# UNITED STATES PATENT AND TRADEMARK OFFICE

APPLICATION NO.	FILING DATE	FIRST NAMED INVENTOR	ATTORNEY DOCKET NO.	CONFIRMATION NO.
10/750,369	12/30/2003	Jens U. Quistgaard	021356-000700US	4885
20350	7590	08/18/2005		
TOWNSEND AND TOWNSEND AND CREW, LLP TWO EMBARCADERO CENTER EIGHTH FLOOR SAN FRANCISCO, CA 94111-3834			EXAMINER IMAM, ALI M	
			ART UNIT 3737	PAPER NUMBER

## Office Action Summary

## DETAILED ACTION

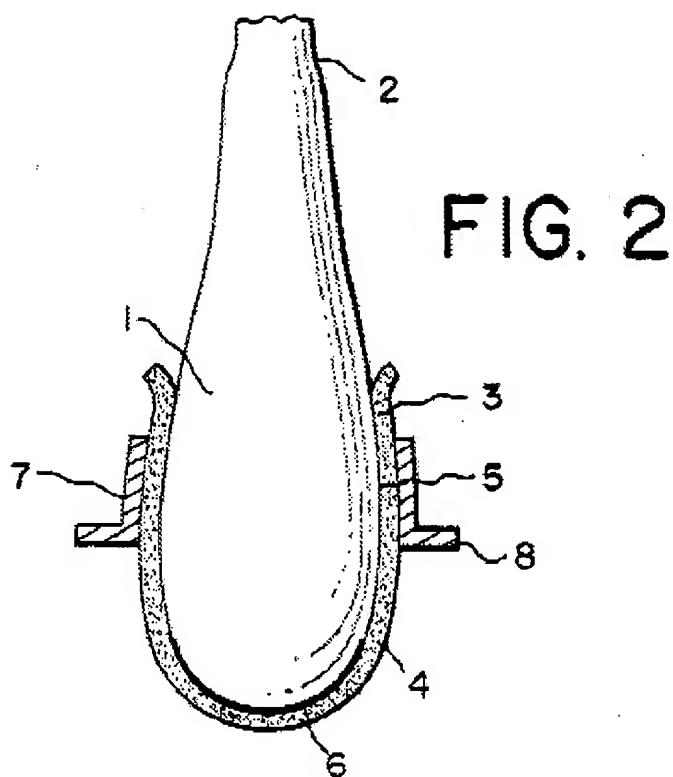
3. Claims 1-3 are rejected under 35 U.S.C. 102(b) as being anticipated by Larson et al. (US 6,039,694 of record).

Larson teaches in col. 5, line 31 - col. 6, line 35 and in Fig. 2 (reproduced below), a method and apparatus for ultrasound therapy including a disposable transducer seal comprising a membrane (3) being substantially transparent to ultrasound energy wherein the membrane is non-porous to water and acoustic coupling fluids; a retainer (7) having a substantially annular configuration for holding the membrane; and a means (col. 5, line 42) for mating the retainer with transducer housing. Larson's invitation of using any other means capable of holding the membrane against the transducer housing (col. 5, lines 40-45) would meet the specific limitations of the dependent claims claimed by the applicant.

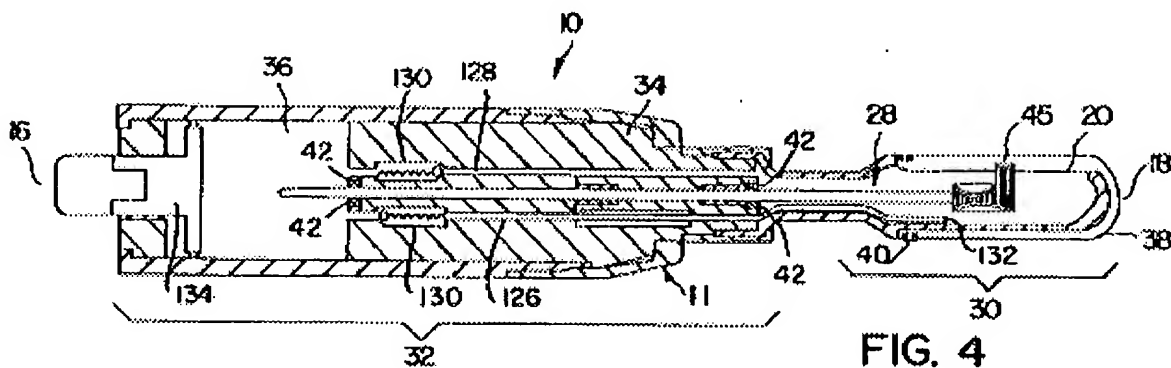
Claim 1 is further rejected under 35 U.S.C. 102(b) as being anticipated by Law et al. (US 5,762,066). Law teaches in Fig. 4 (reproduced below), an apparatus for ultrasound therapy using high intensity focused ultrasound (HIFU) including a disposable transducer seal (42) comprising a membrane (38) being substantially transparent to ultrasound energy wherein the

membrane is non-porous to water and acoustic coupling fluids; a retainer having a substantially annular configuration for holding the membrane (col. 14, lines 19-28 also see Figs. 1 and 12 item 90; and a means (90) for mating the retainer with transducer housing.
